RE: TFN 5 5/166, Uranerz Energy Corporation, Nichols Ranch ISR Project, Permit to Mine No. 778
Jane Dough Amendment, Round 1 Technical Comments

Jane Dough Amendment, Permit No. 778
TFN 5 5/166
Round 1 Technical Review Responses

URANERZ RESPONSE TO WDEQ/LQD COMMENTS

NICHOLS RANCH ISR PROJECT
FIGURE 1-5
NICHOLS RANCH UNIT
SITE FACILITY DIAGRAM

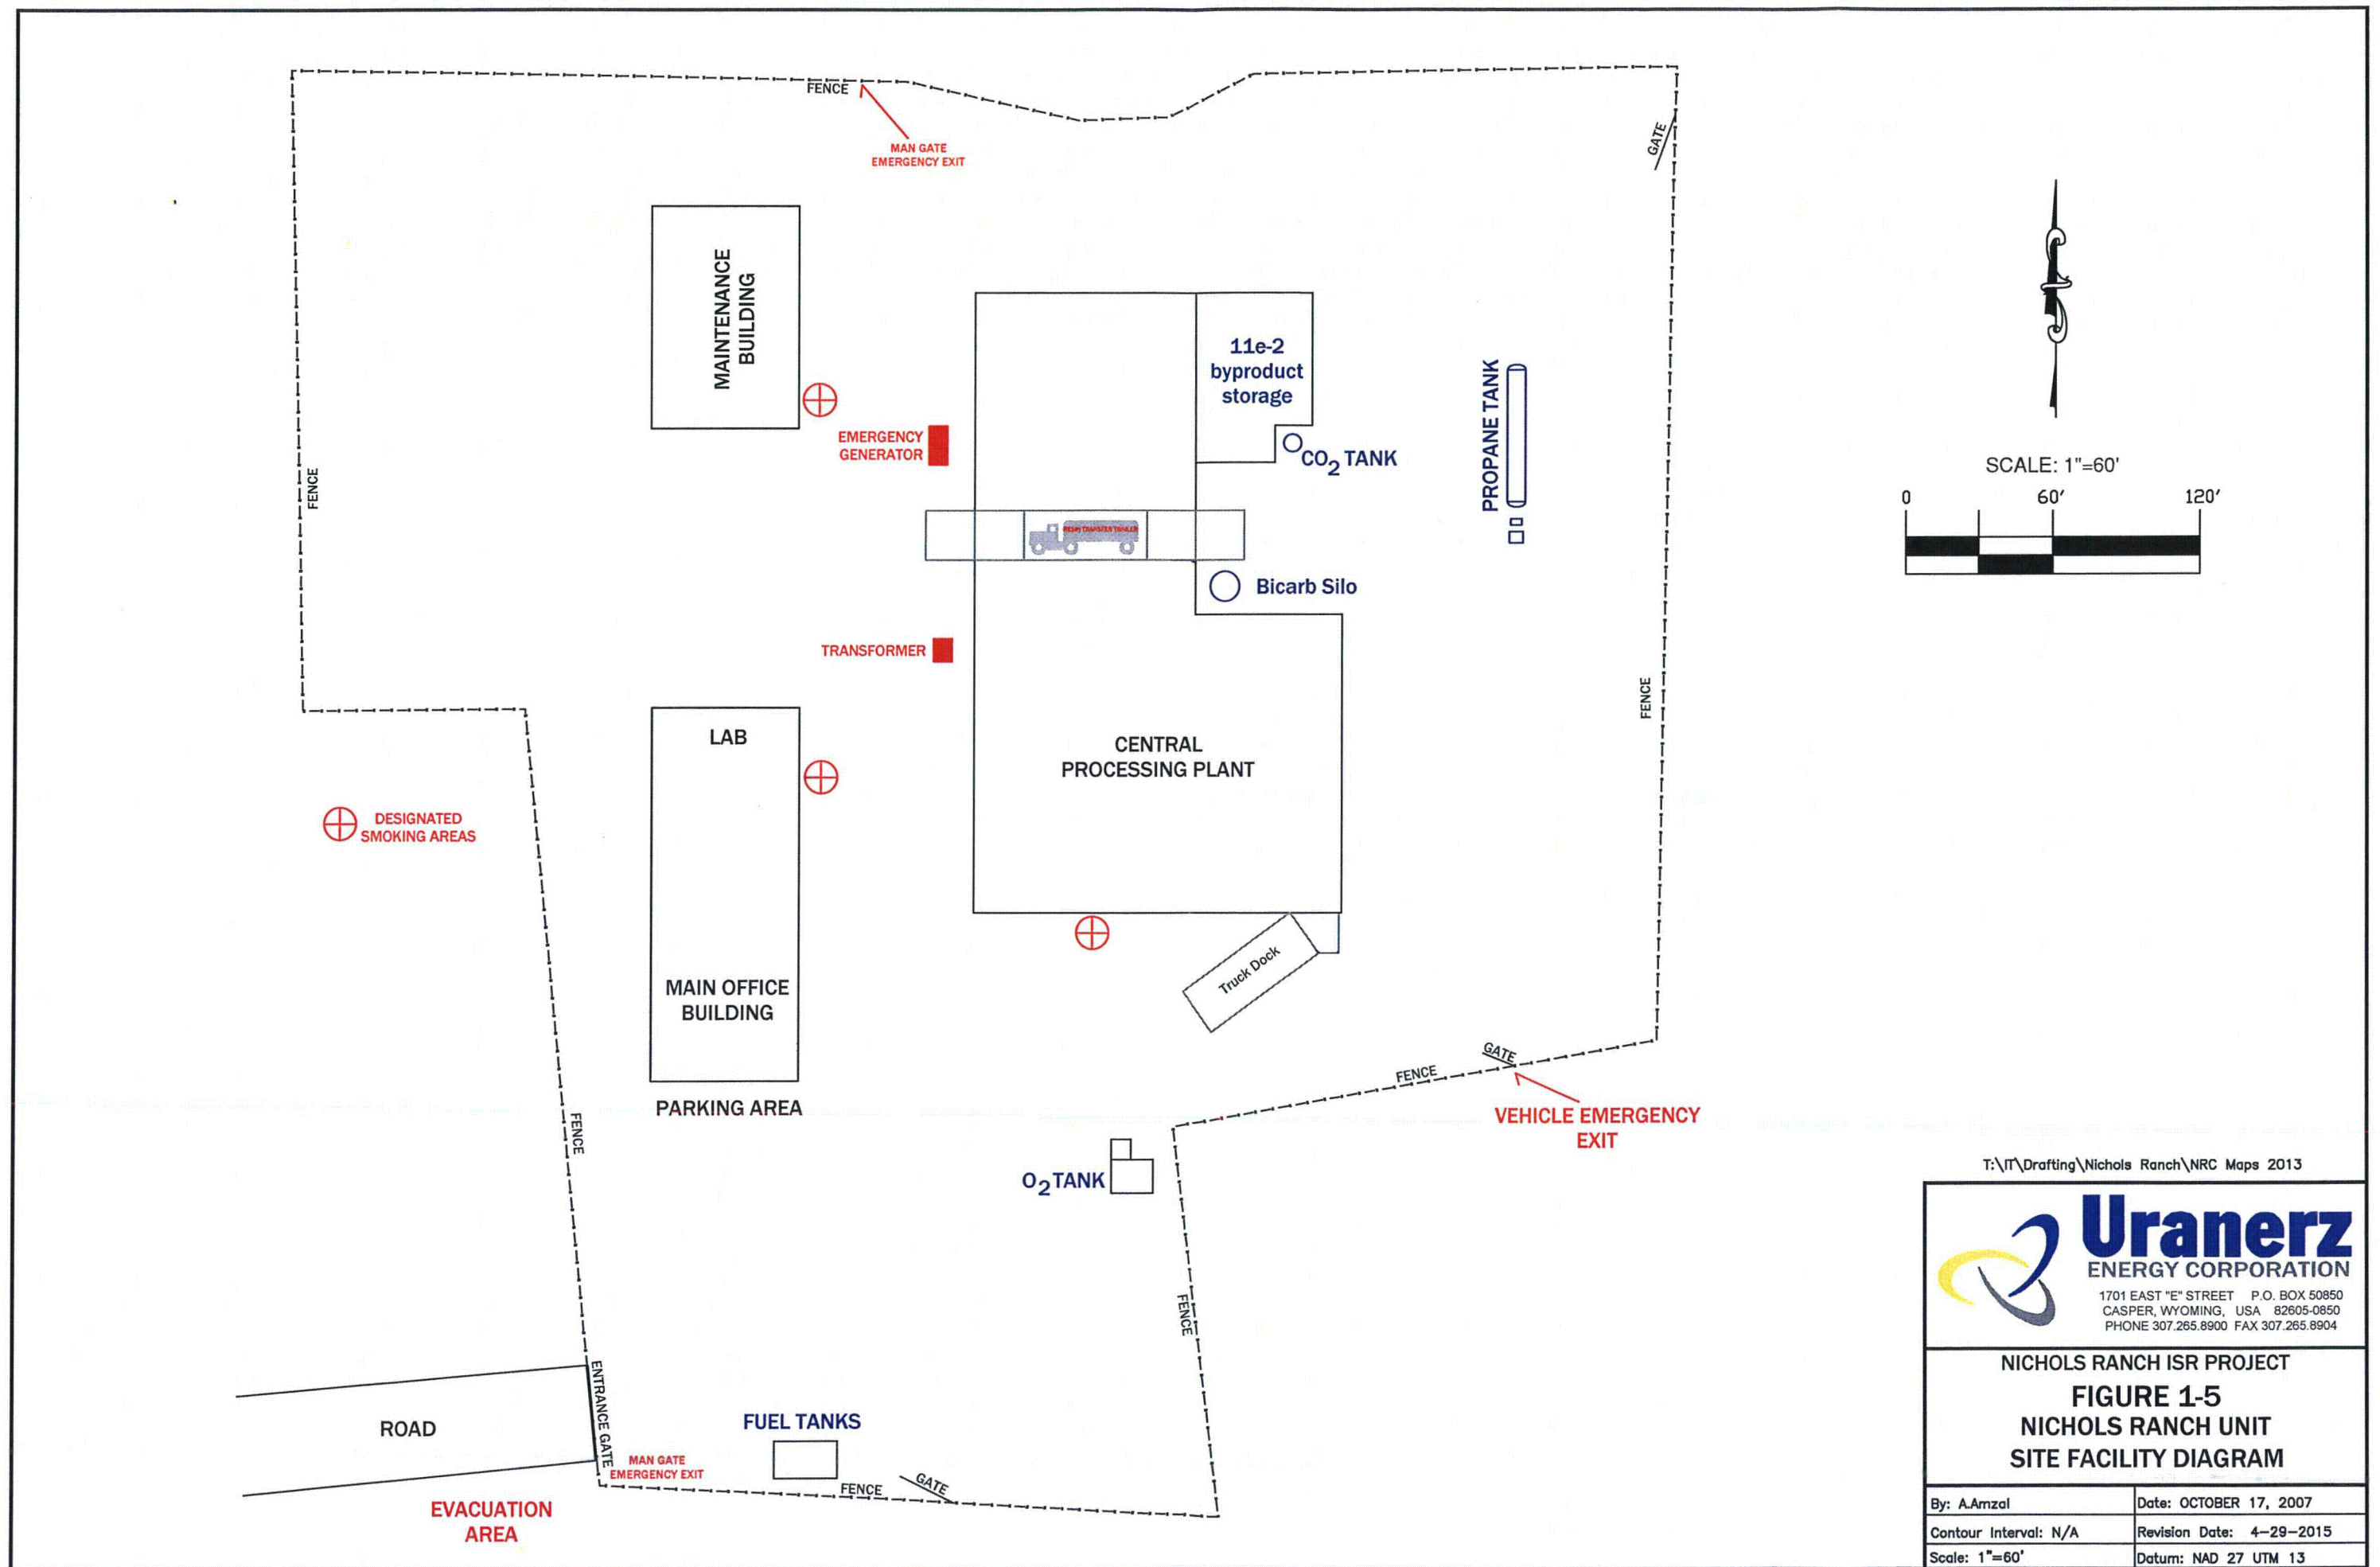
12. 3.13.2.2.2 WDEQ/LQD Comment: Add reference to which map shows the 11.e(2) disposal area(s).

Uranerz Response: A reference has been added to Section 3.13.2.2.2 and Figure 1-5 is being submitted as an updated figure. The revised pages are enclosed.

FIGURE 3-18 URANERZ ORGANIZATION

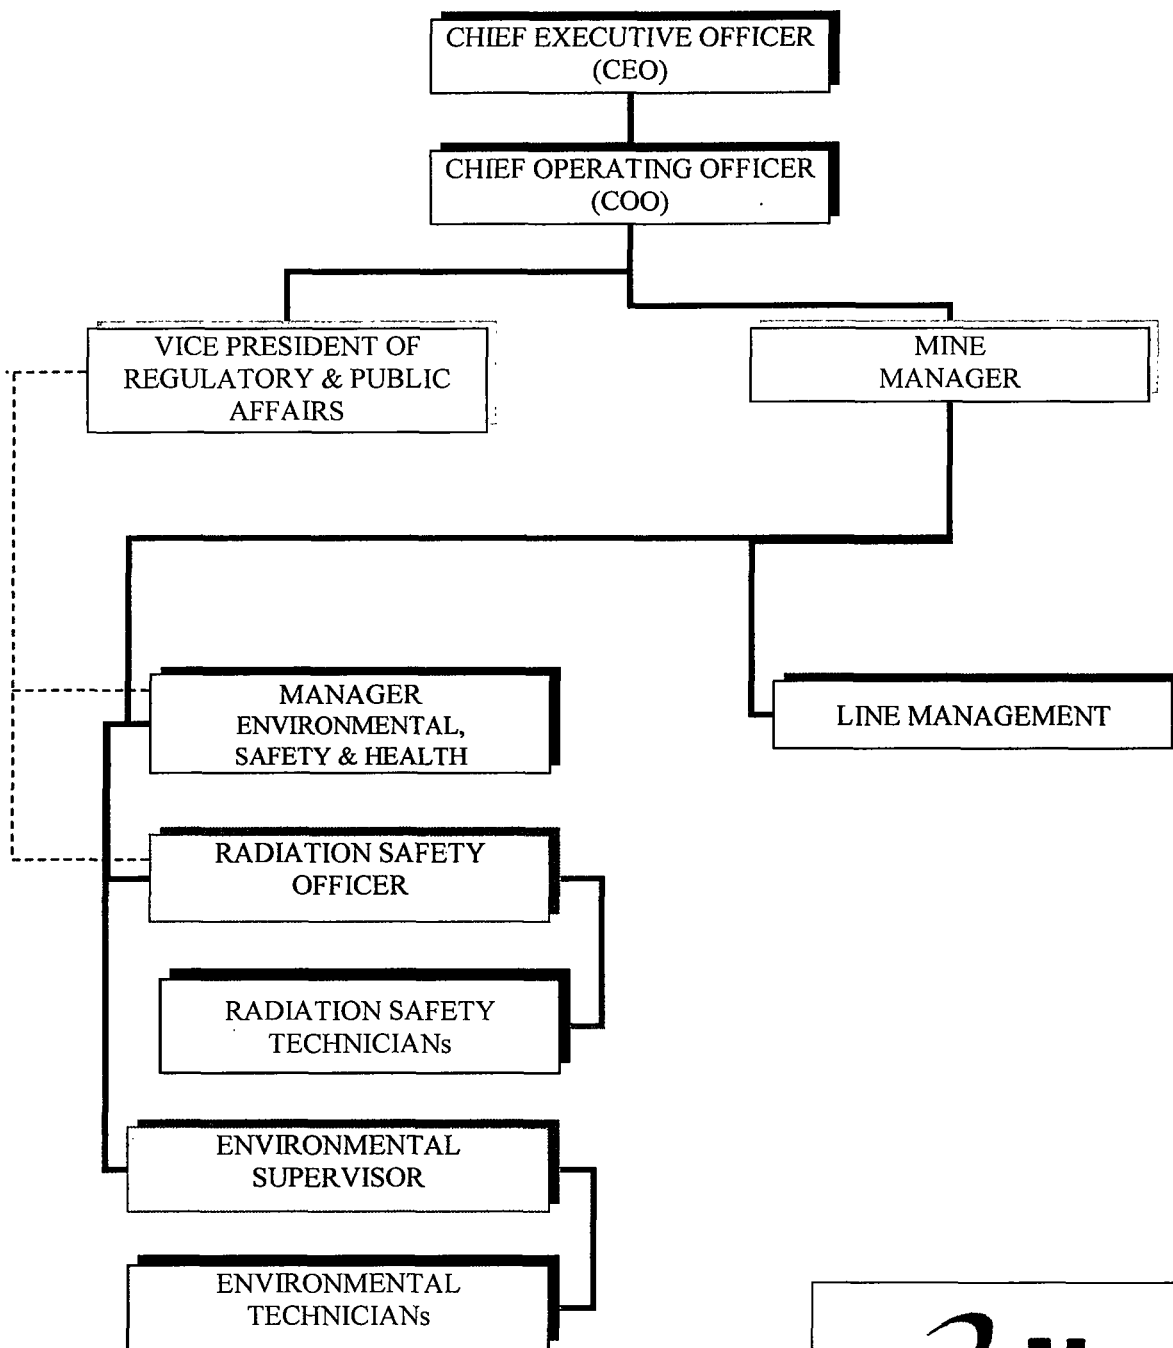
2. WDEQ/LQD Comment: Verify that the changes to the organizational structure, which were tracked under TFN 6 5/124 and approved on March 6, 2015 as Change #12 were included in the amendment package.

Uranerz Response: Agreed. Uranerz has incorporated the organizational structure changes approved as Change #12, into the amendment package. The changed documents are included and provided for on the attached Index of Change.
